WORKSHOP AGENDA

Planning Commission

Item #: 3. Site Plan – Smoke Club 13 – New Building of 2,759 Square Feet on 0.42 Acres. Requested by Dean Design Group. Property located at 5234 Murfreesboro Road (Tax Map 15M, Group C, Parcel 6). C-2 (Highway Service) Zoning District. Property owned by Smoke Club 13, LLC.

Staff Comments / Technical Items:

Final Sediment Control Plan Grading & Drainage Plan

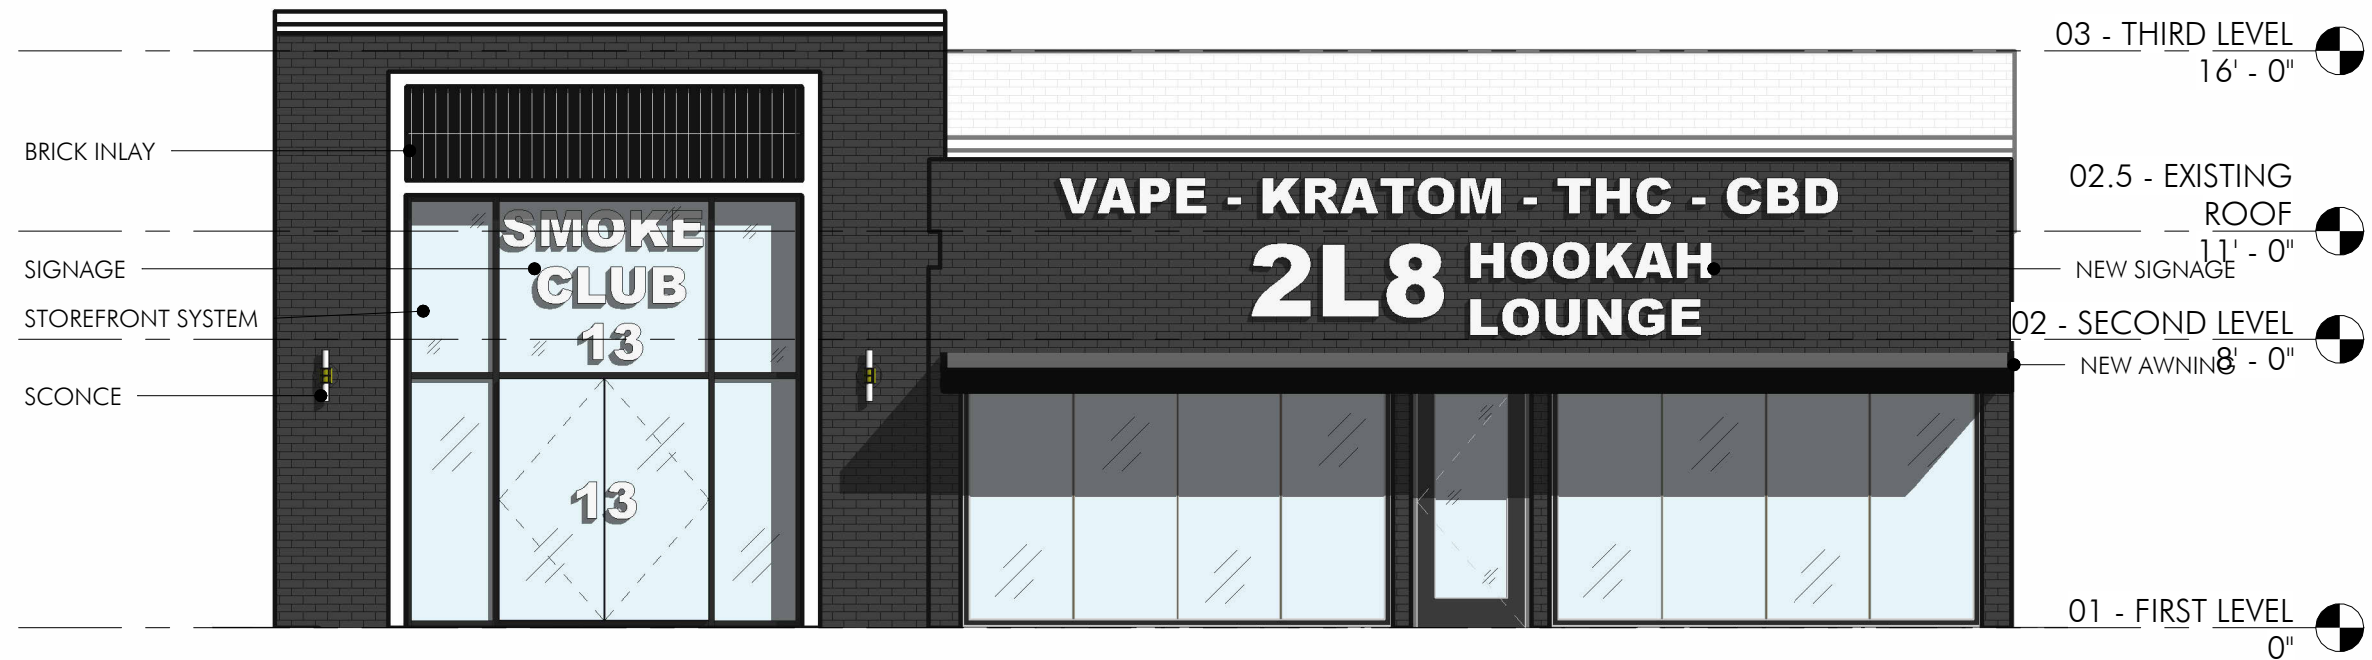
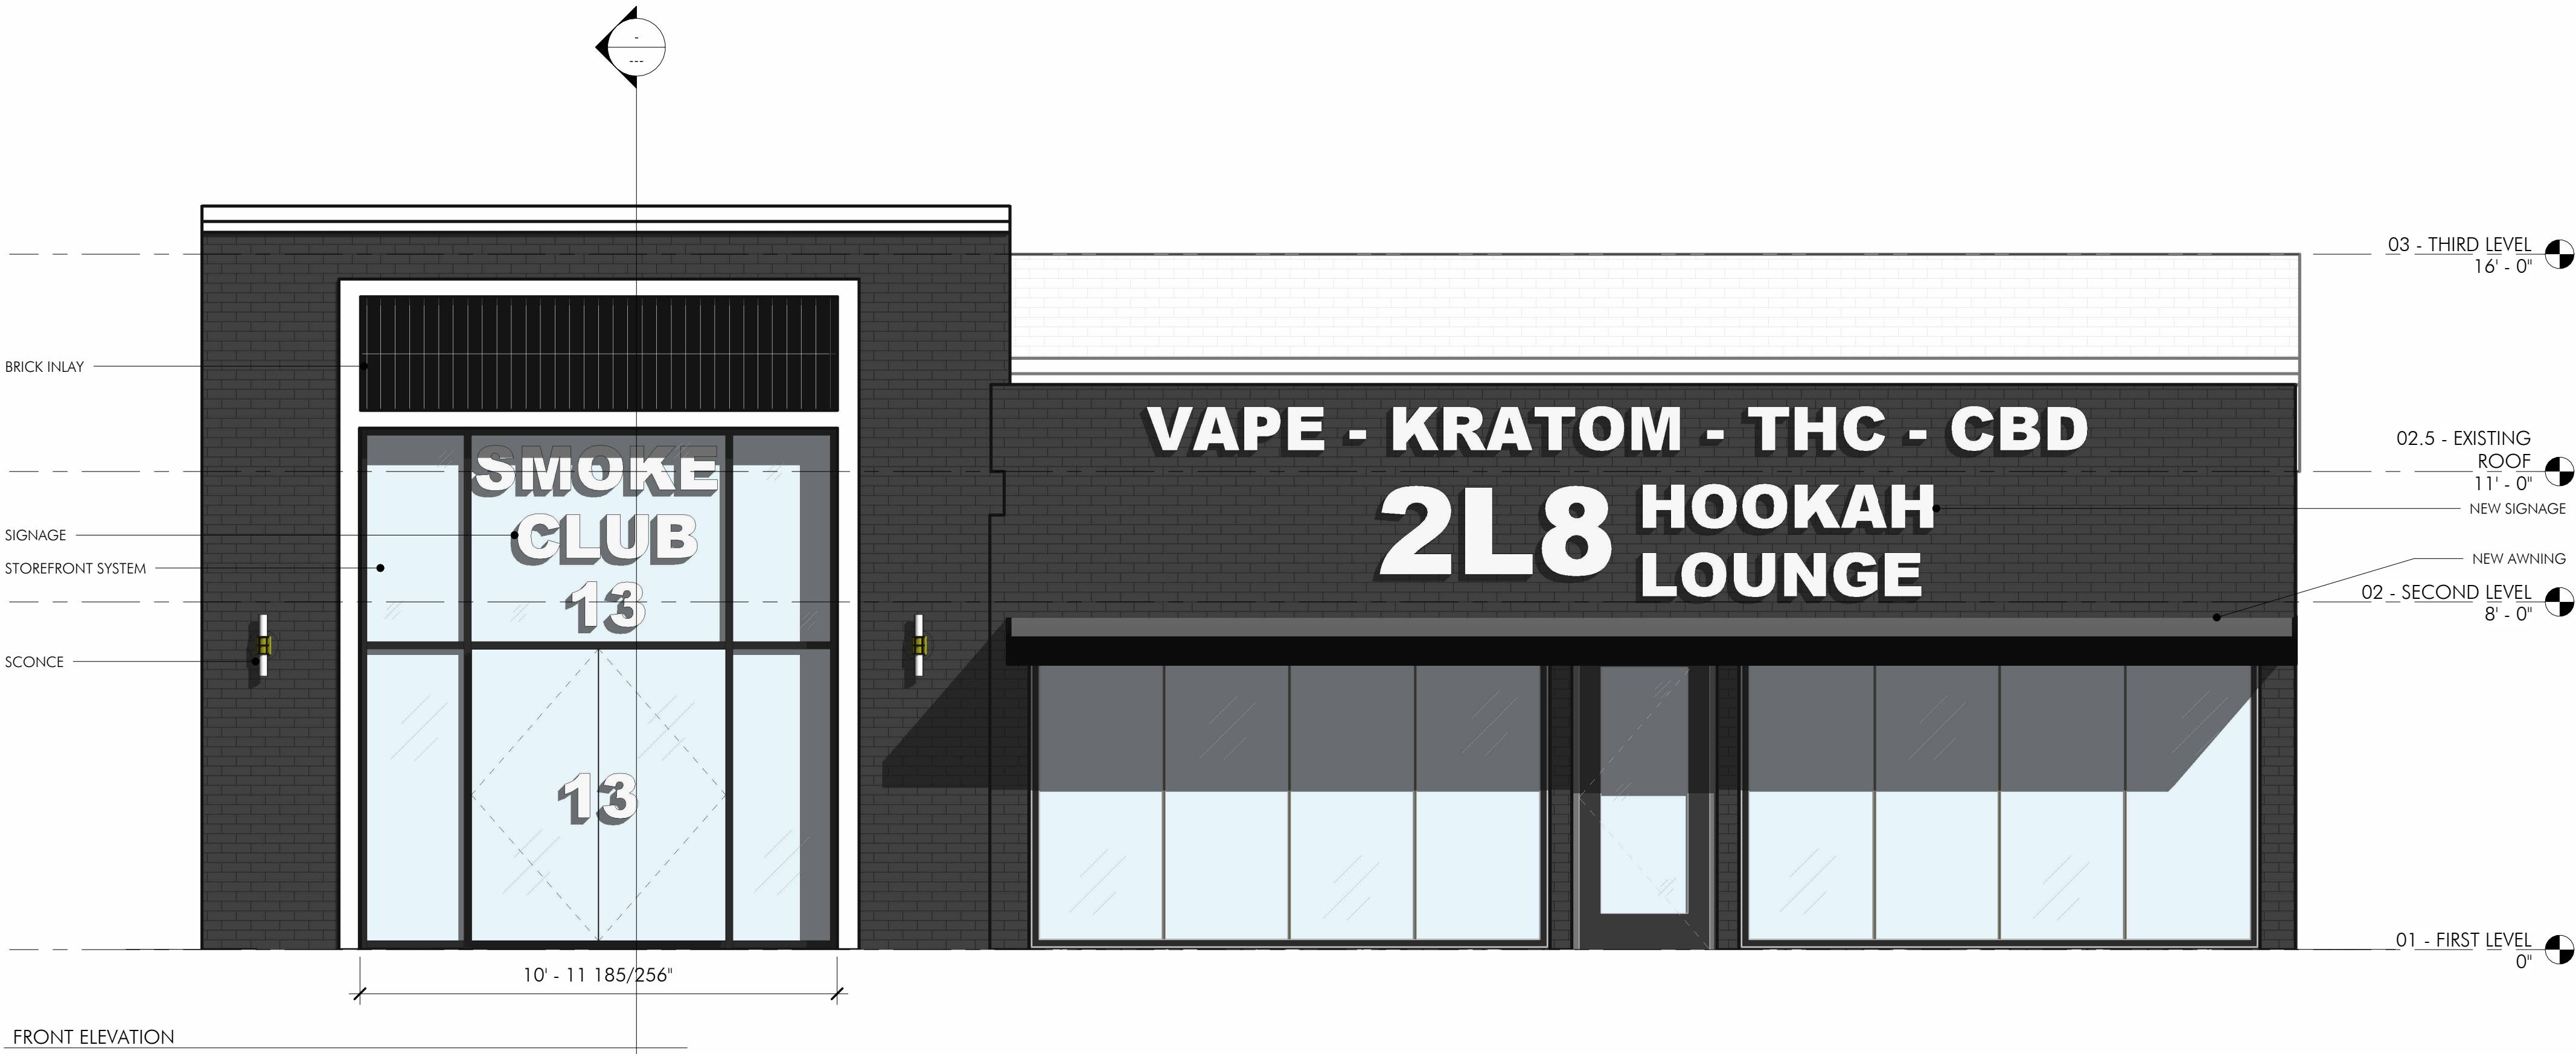
4. Show a structural section of the proposed retaining wall. The note that the design will be done by others is not acceptable for walls which are required to comply with Site Plan requirements. Please include a detail for how the wall will pass the outfall pipe from the bioretention pond which is hitting it at an extreme angle or add a traffic-rated handhold to create a perpendicular connection of the pipe with the wall.
5. Provide calculations for the WQTV per the requirements of the La Vergne Stormwater Management Ordinance (https://www.lavergnetn.gov/DocumentCenter/View/4047/Title-14---Zoning-and-Land-Use-Control_APPROVED-2023-10-10)
6. On the pavement detail, show that subgrade must be compacted to 95% Standard Proctor (ASTM D698). Also state that asphalt and aggregate materials must meet City of La Vergne Standard Roadway Specifications.

C3.1
GRADING PLAN

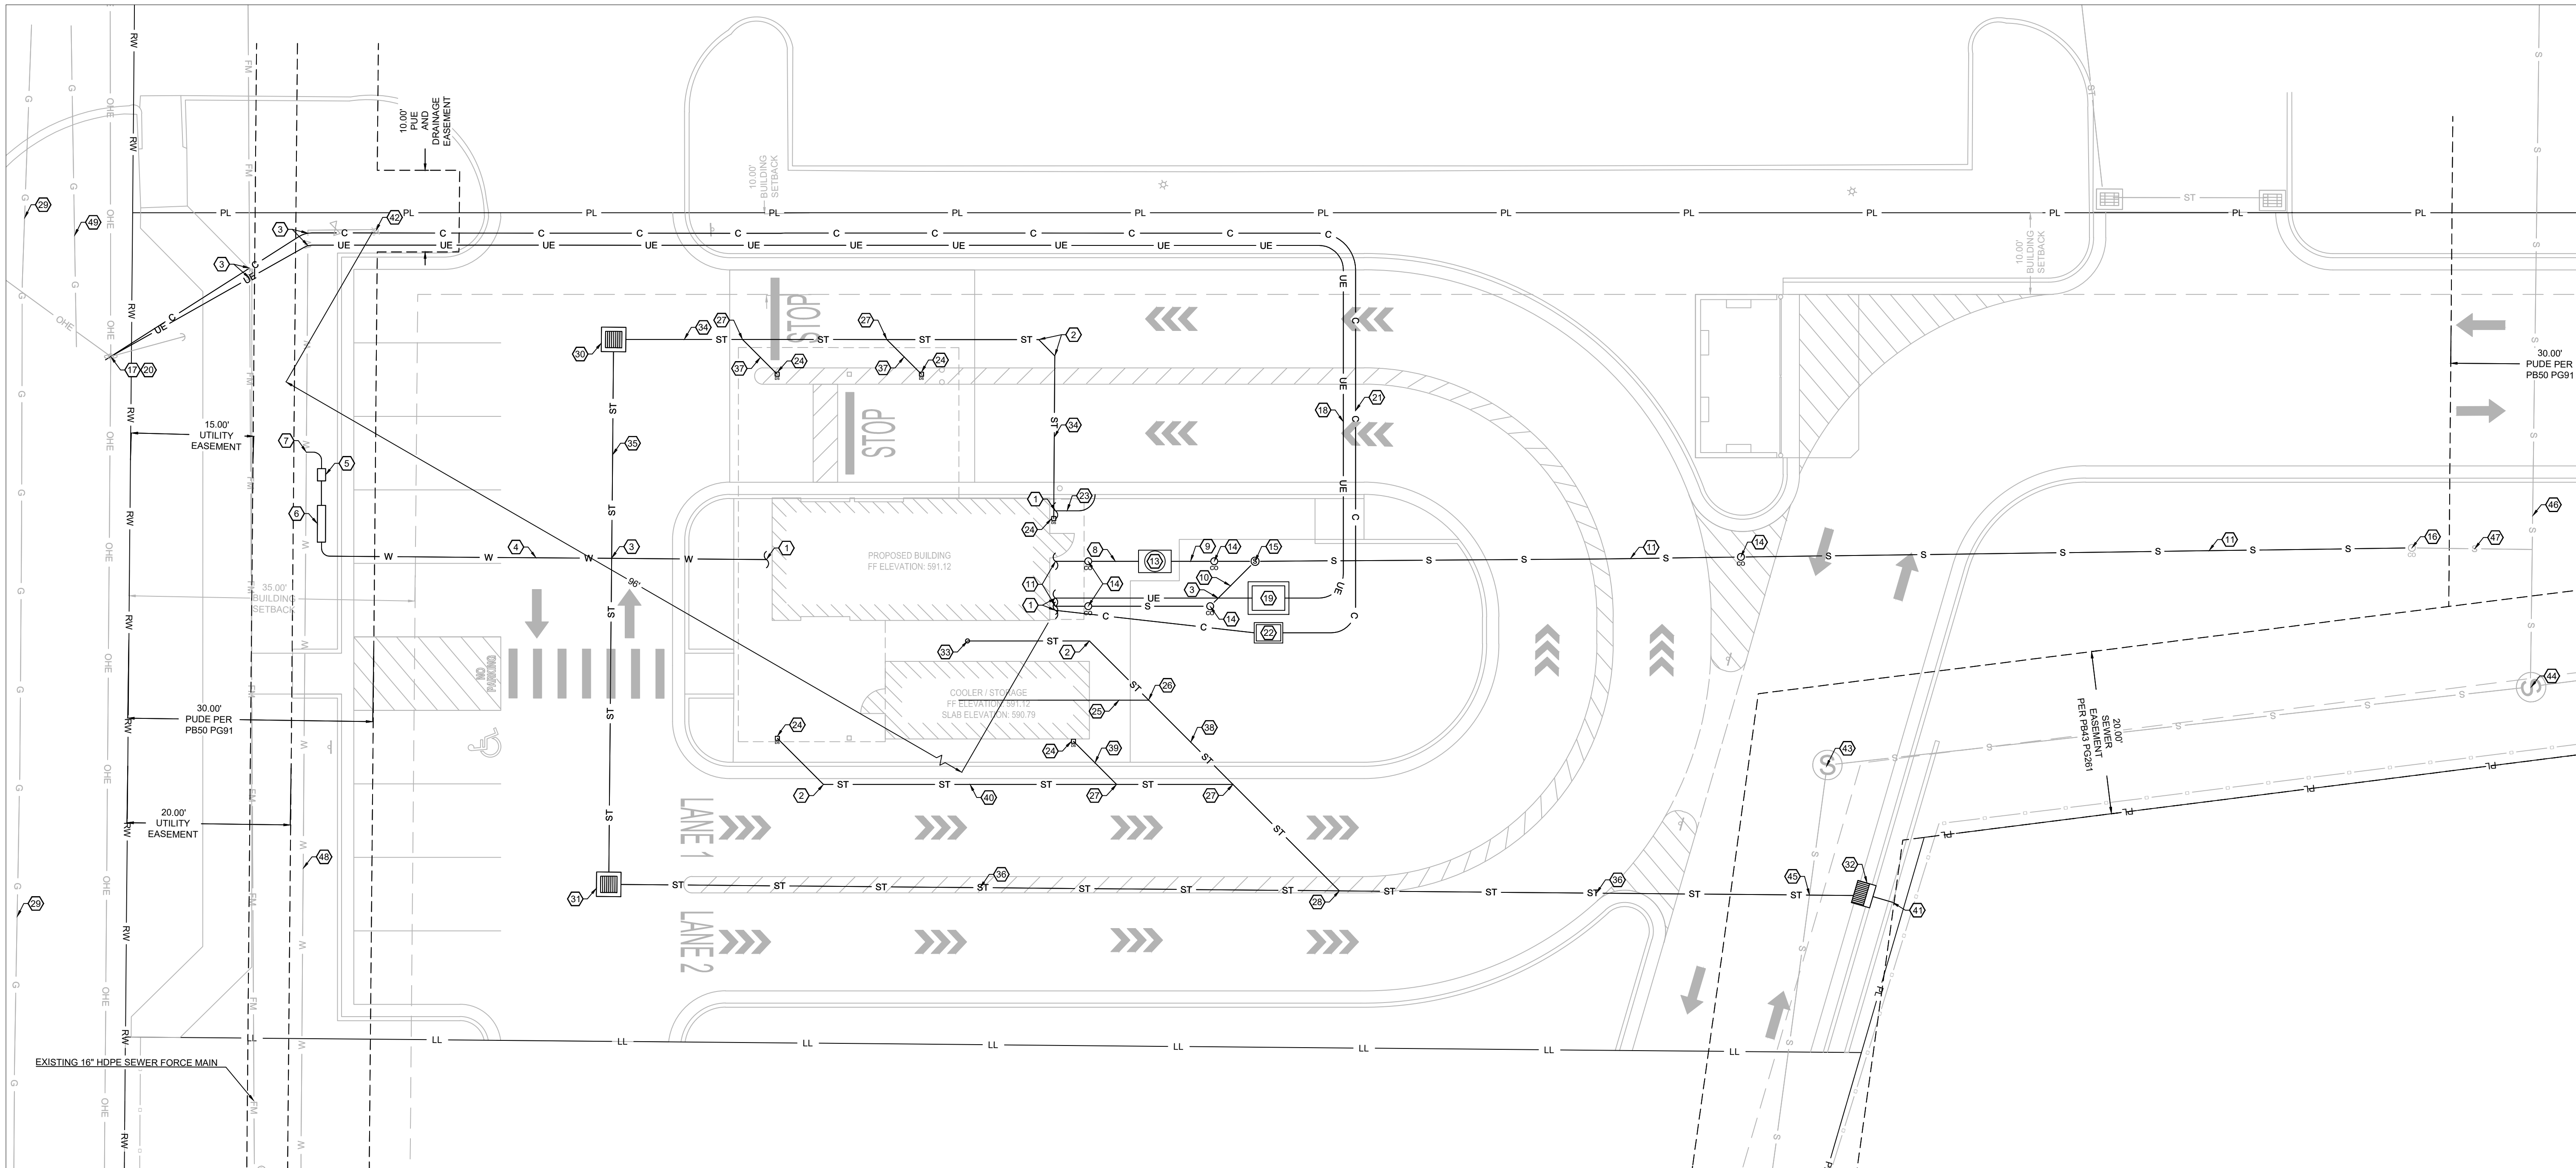
1. (Sheet C3.1) Show rip rap pad/strip or other energy dissipation device between headwall 41 and property line.

C-2.1

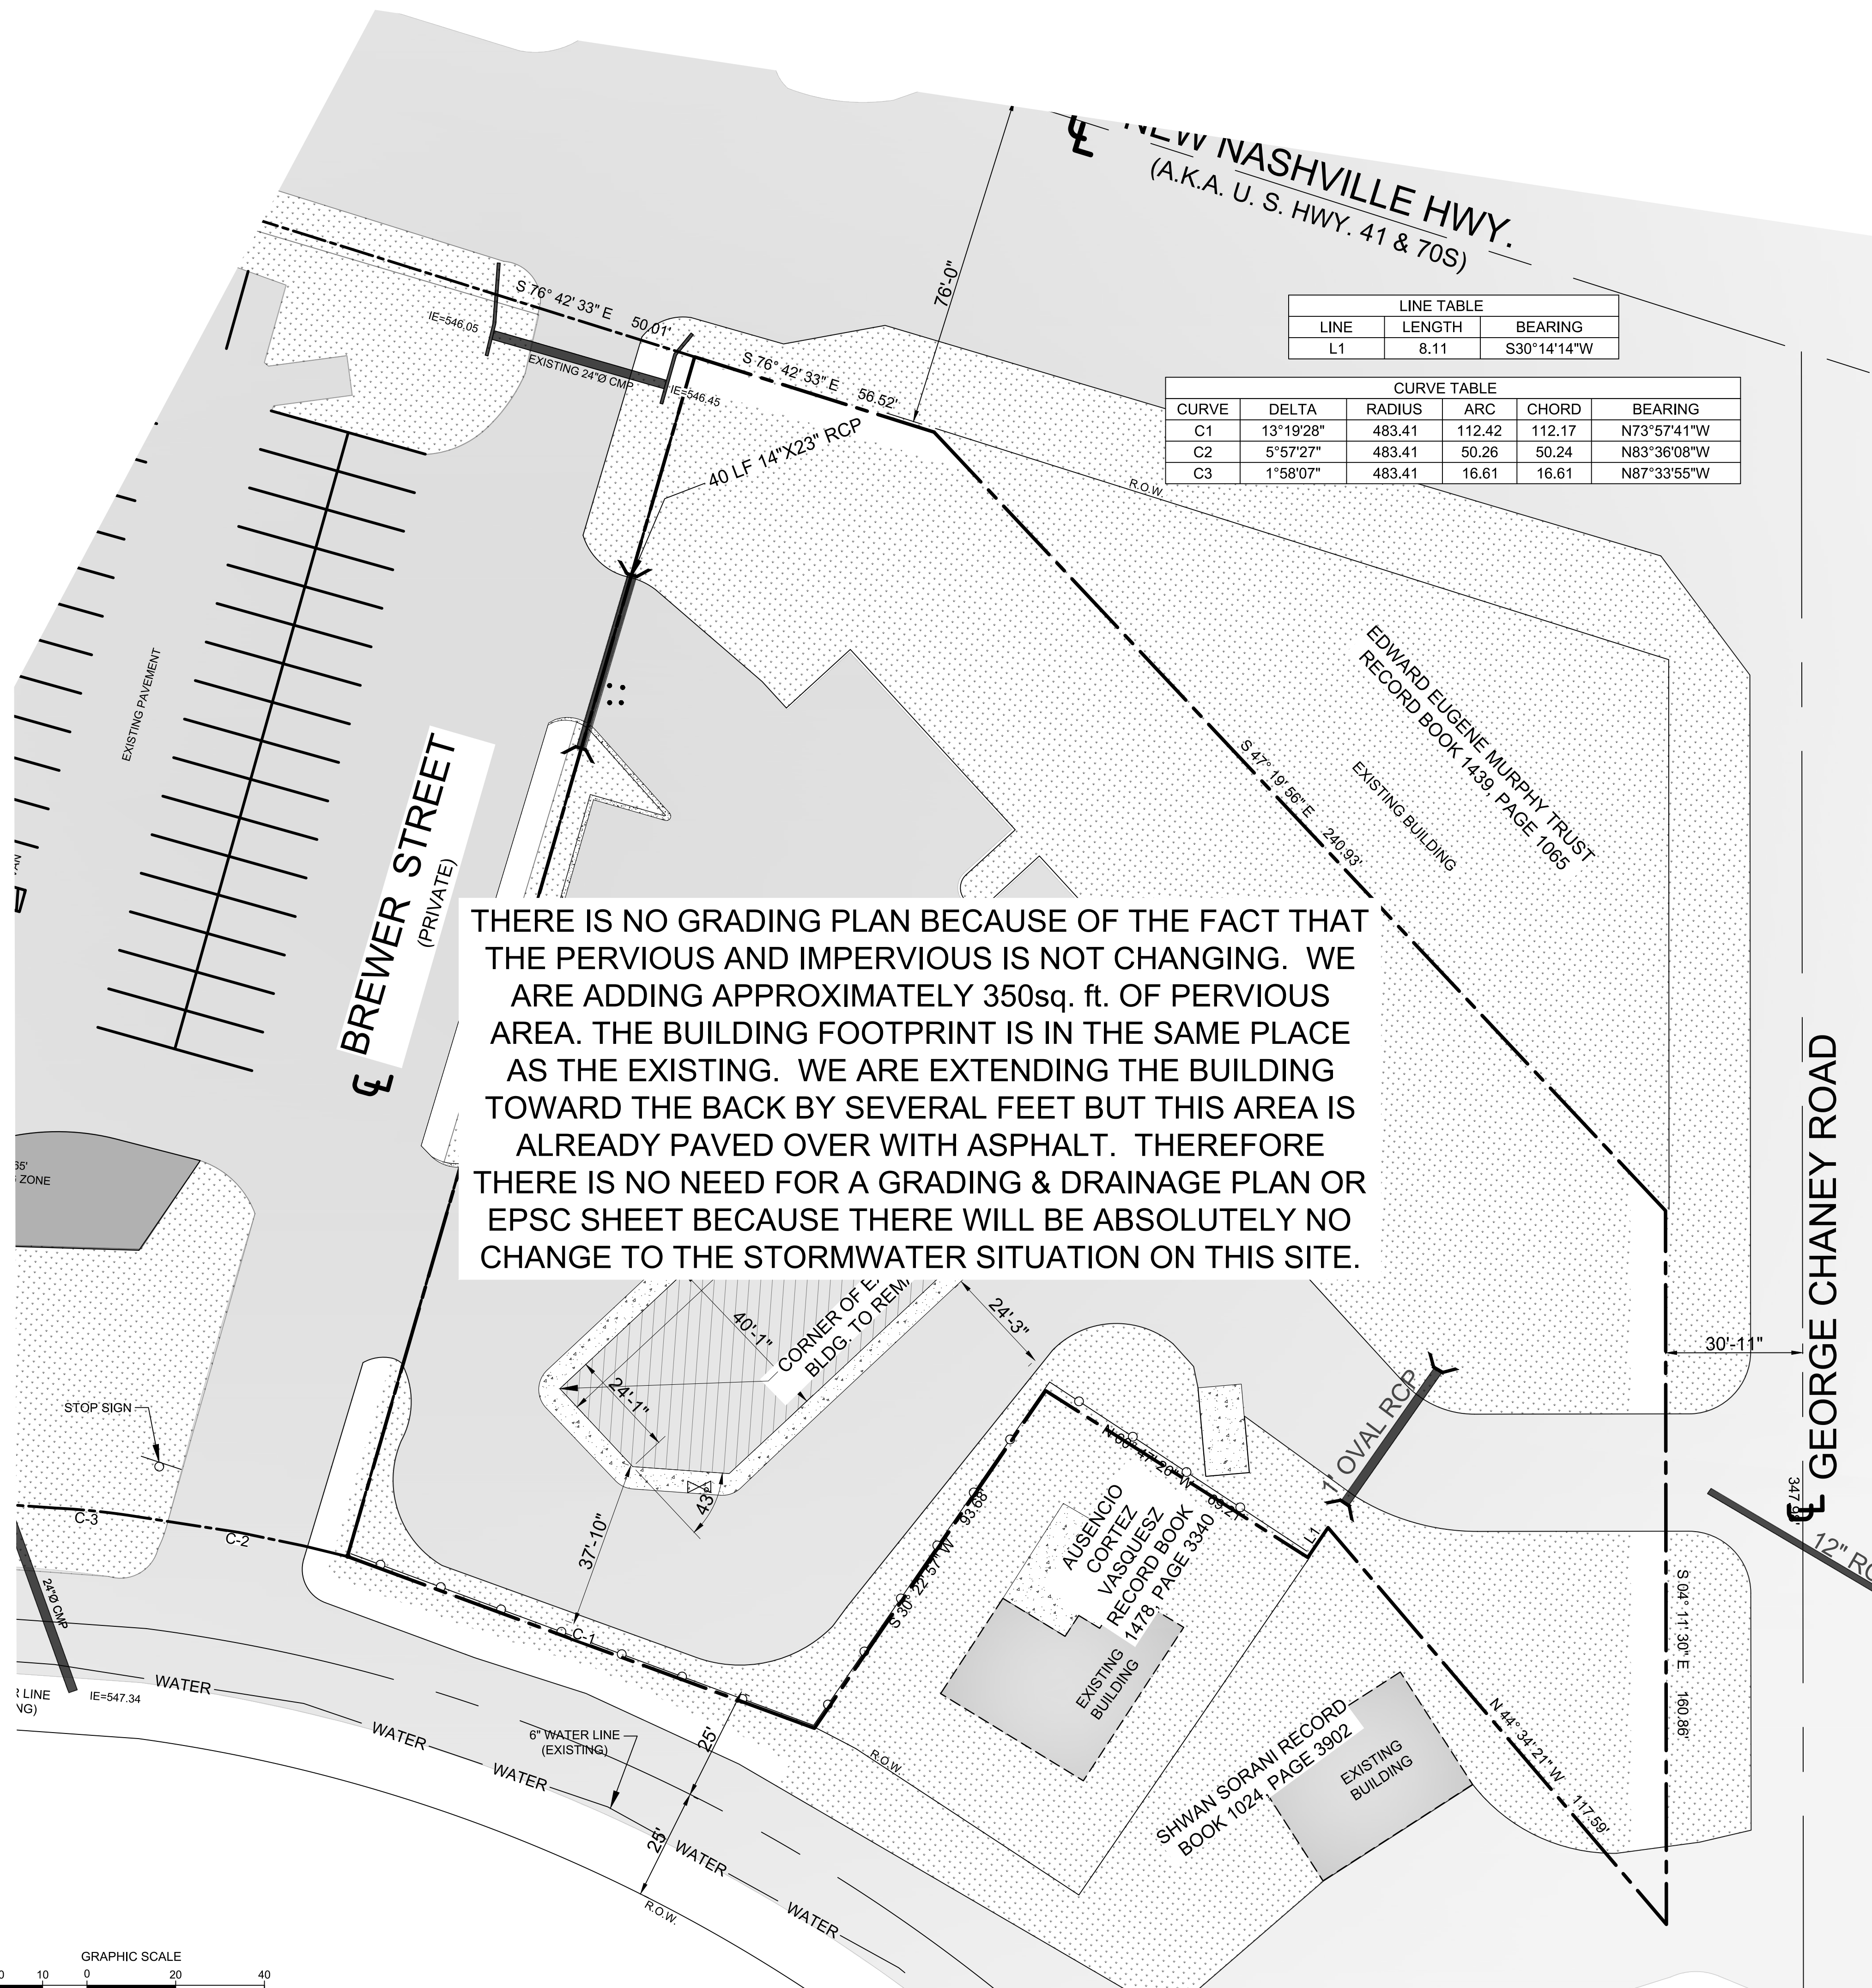
7. (Sheet C-7.0) The silt fencing shown on the intermediate EPSC plan should be shown on the Initial EPSC Plan (C-7.0).
8. (Sheet C-2.1) It is strongly preferred by staff to connect the proposed walk along Brewer Street with the proposed sidewalk along Murfreesboro Road.
